Kirby Morgan Dive Systems, Inc.®

Bulletin #6 of 2010. October 6, 2010

Change To Product Bulletin

Length of Part Number 530-024, Screw, Increased

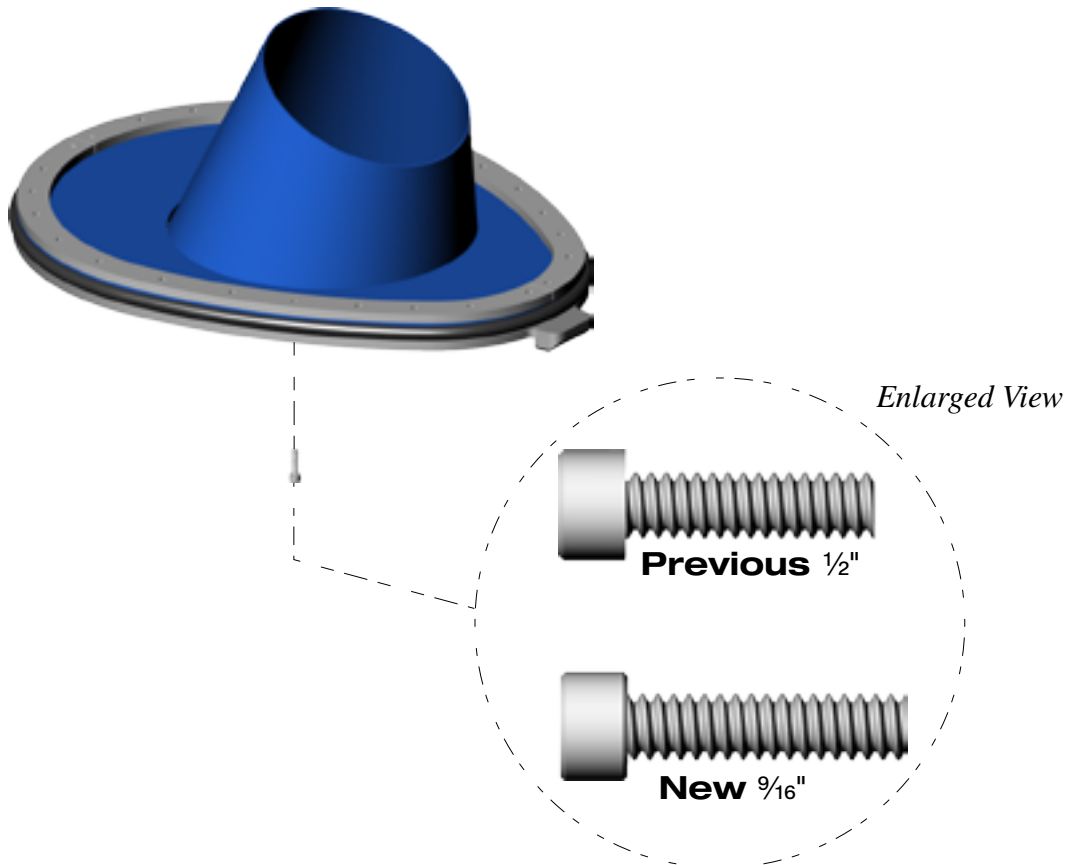
Kirby Morgan has slightly increased the length of part number 530-024, neck ring assembly screw, to better accommodate the various dry suit neck dams (latex and neoprene) that may have variations in thickness. This will help provide maximum thread engagement.

The length of the screw was increased from $\frac{1}{2}$ " to $\frac{9}{16}$ ".
